ADDENDUM NUMBER: Three (3)

DATE: December 1, 2025

PROJECT: MONTGOMERY COUNTY EMS STATION 28

DESIGNER: DOUGLAS A. JONES, ARCHITECT

SHEET EO.1 - ELECTRICAL SITE PLAN; Delete Sheet EO.1 dated 11/12/2025 in its entirety. Substitute therefor: Sheet EO.1 - ELECTRICAL SITE PLAN dated 12/01/2025 attached hereto.

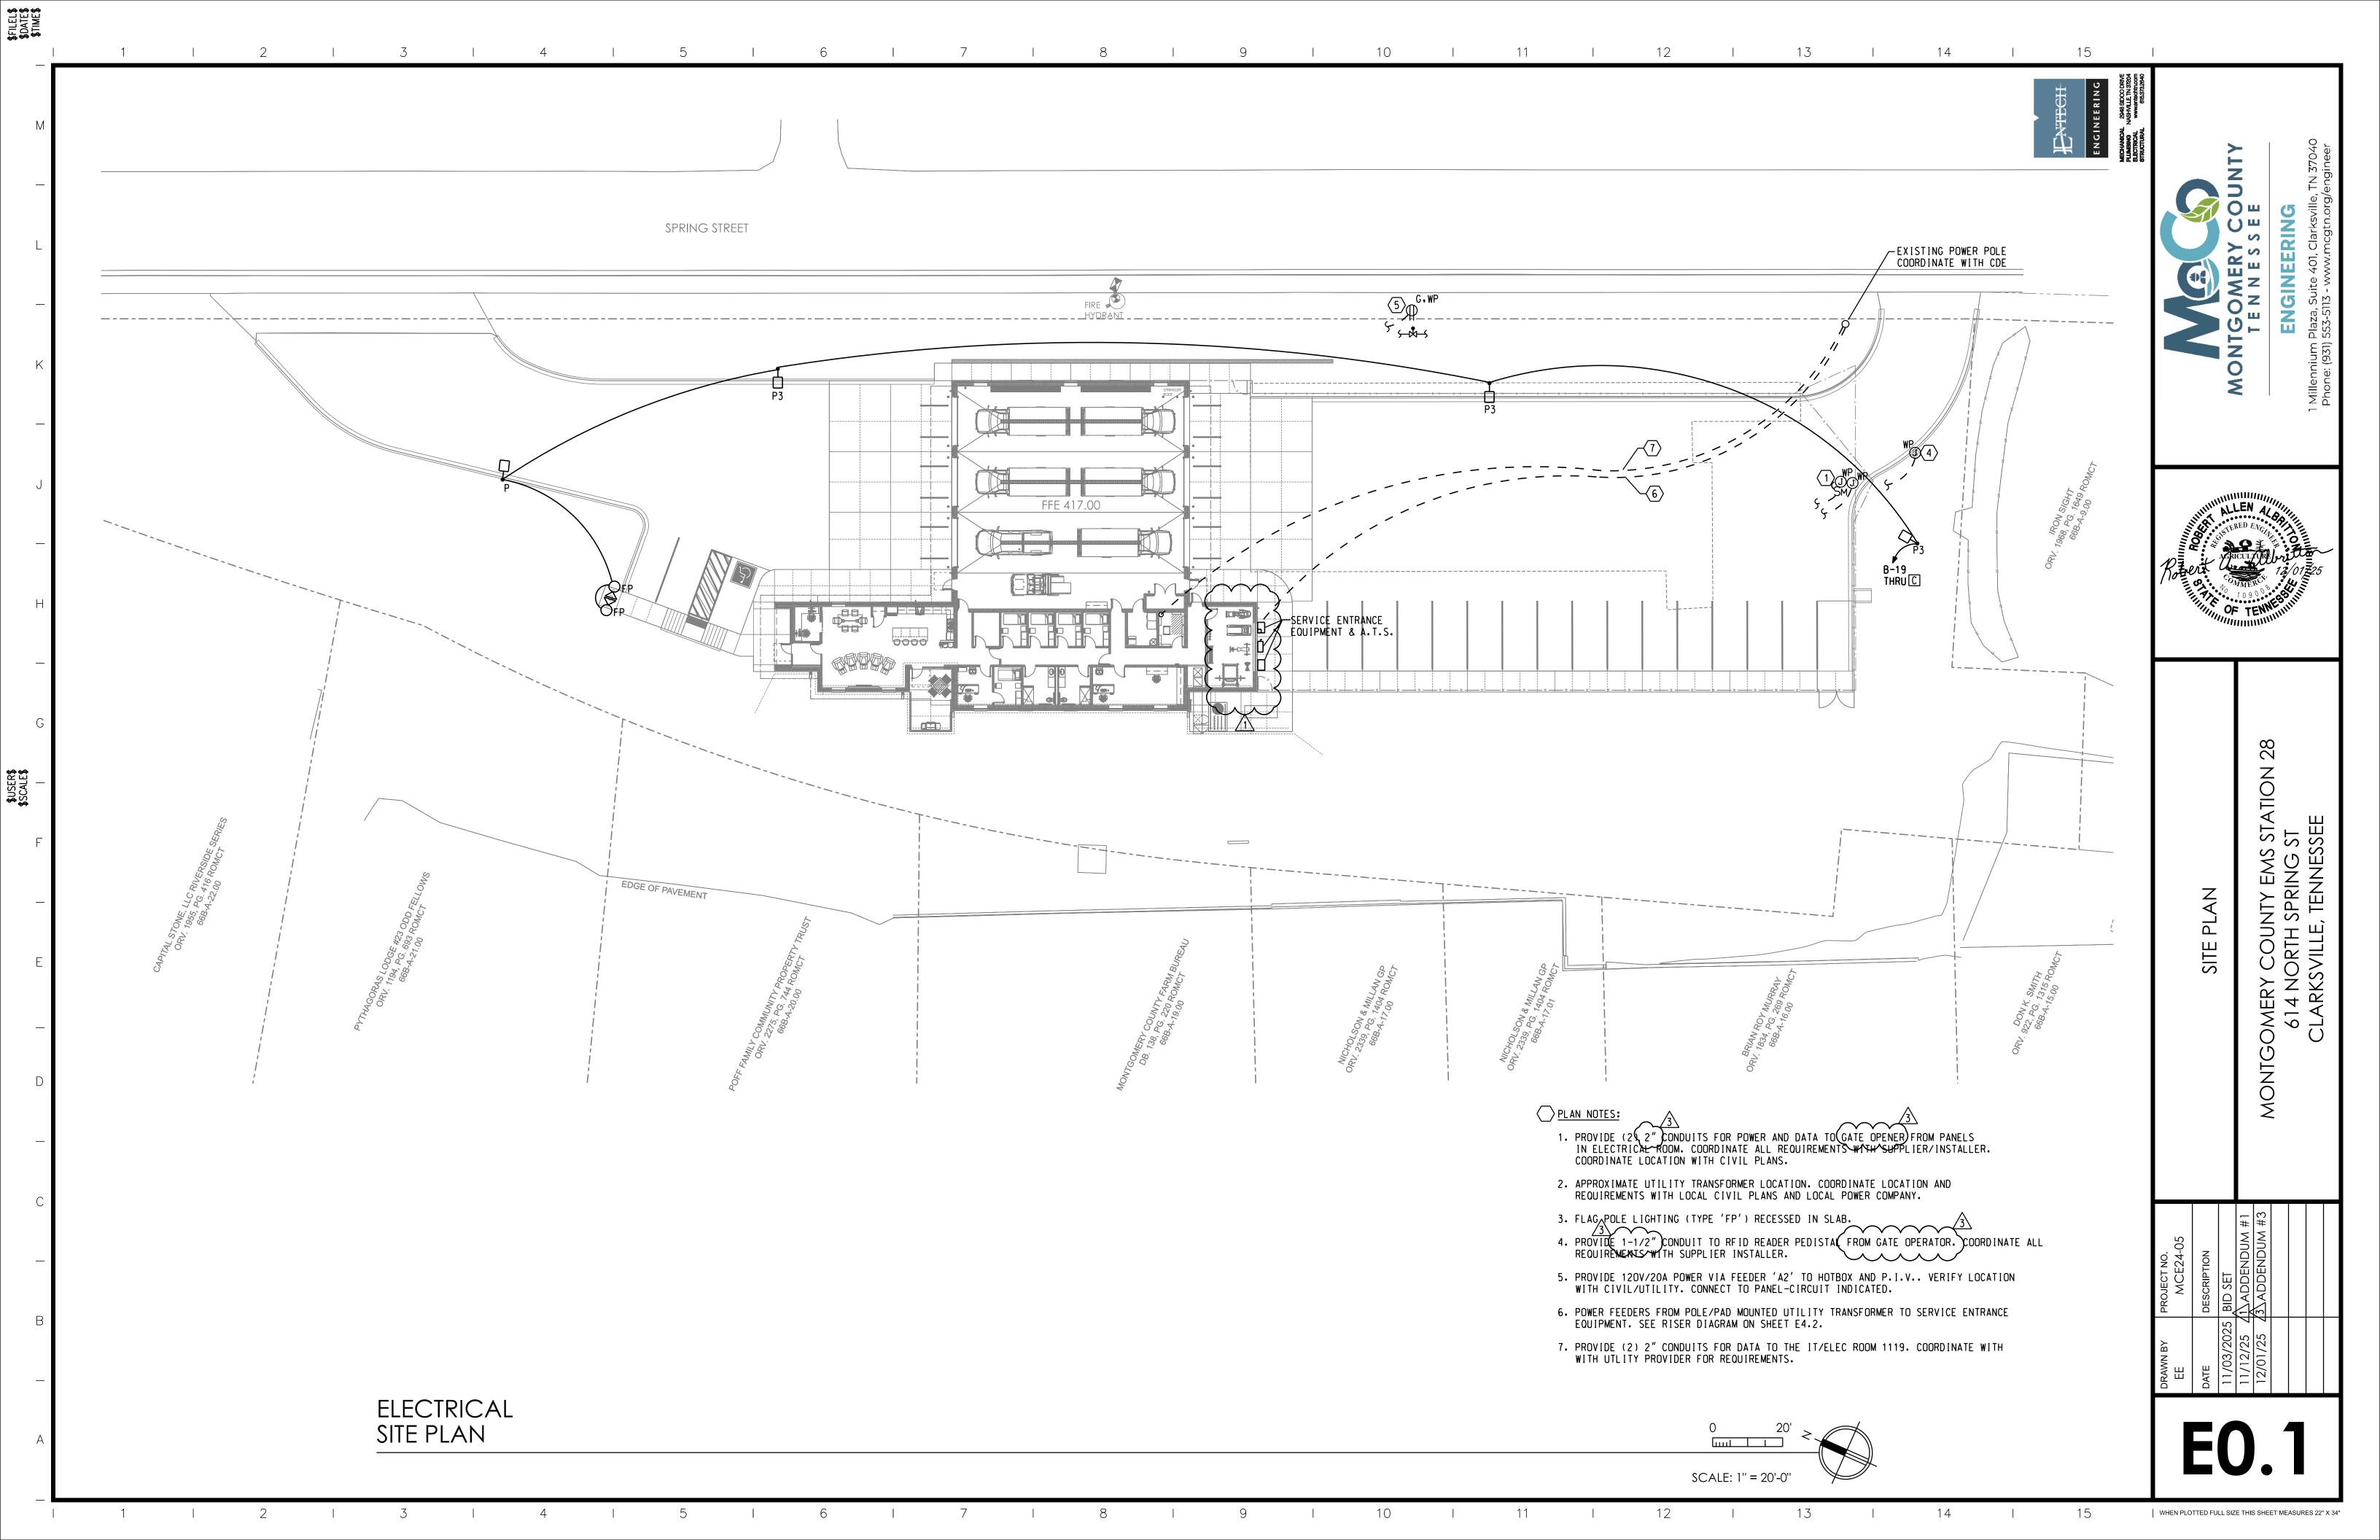
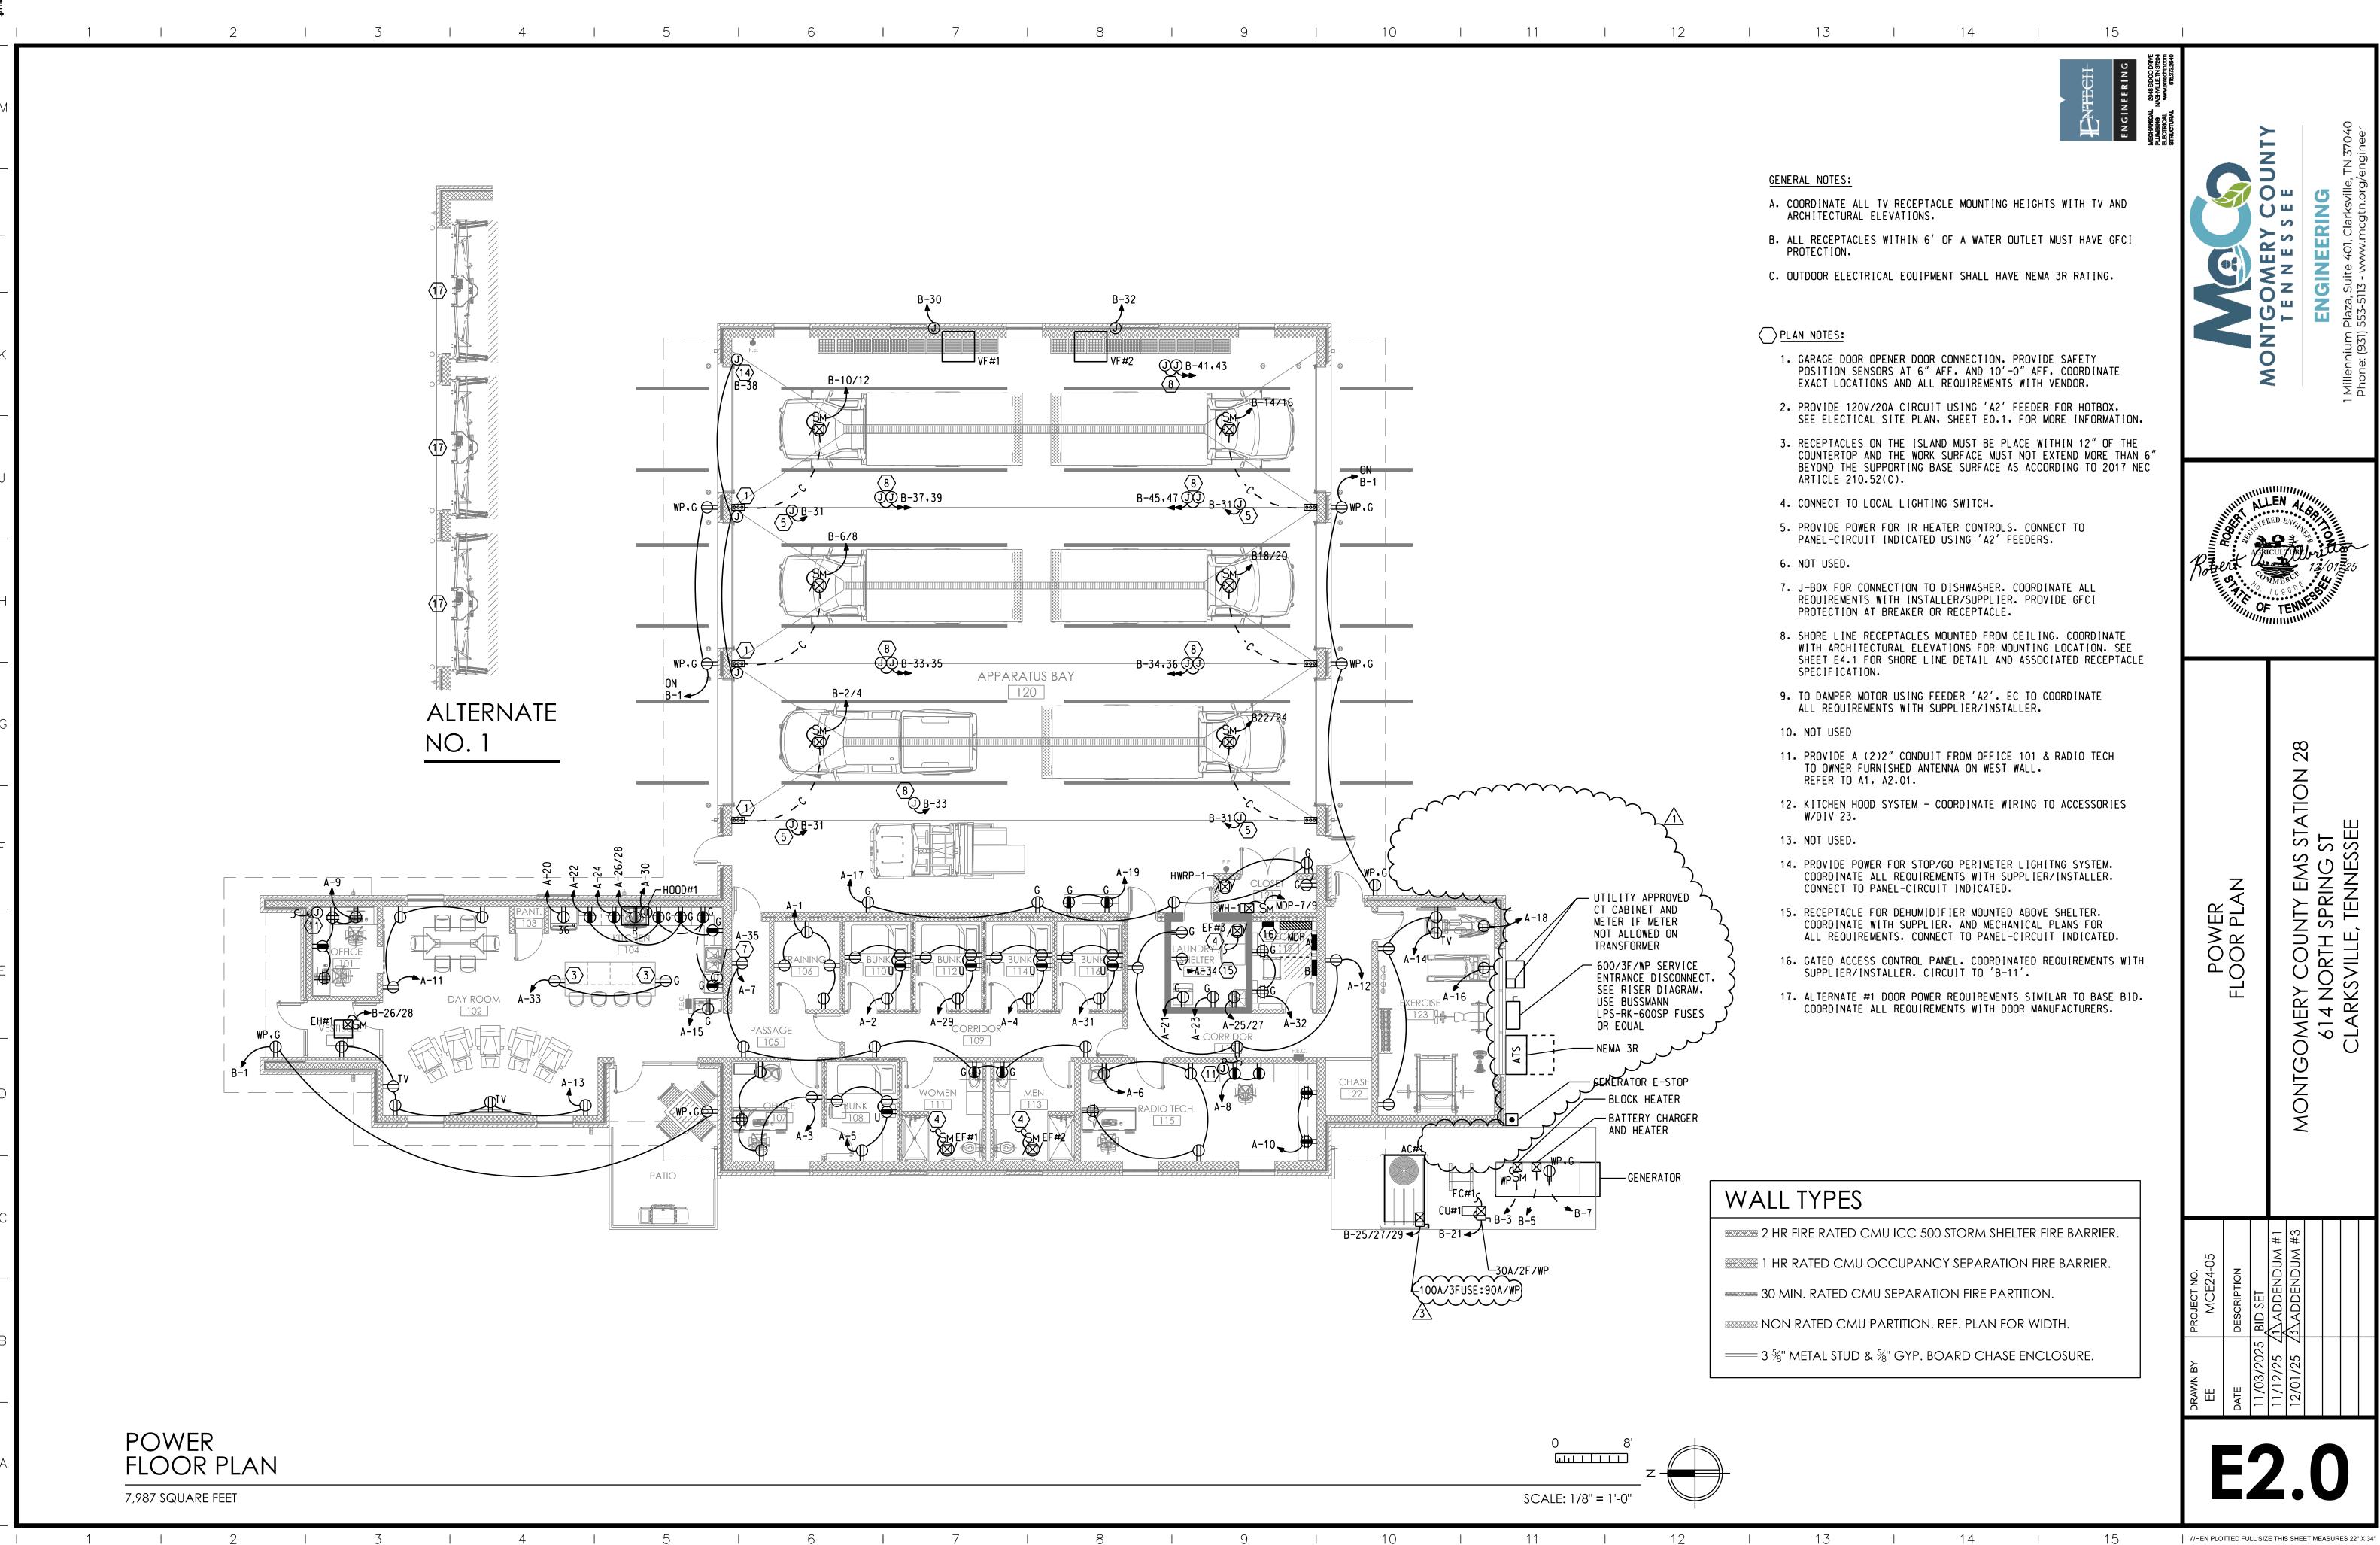
Clarification: Resized data conduits to gate controller & credential pedestal.
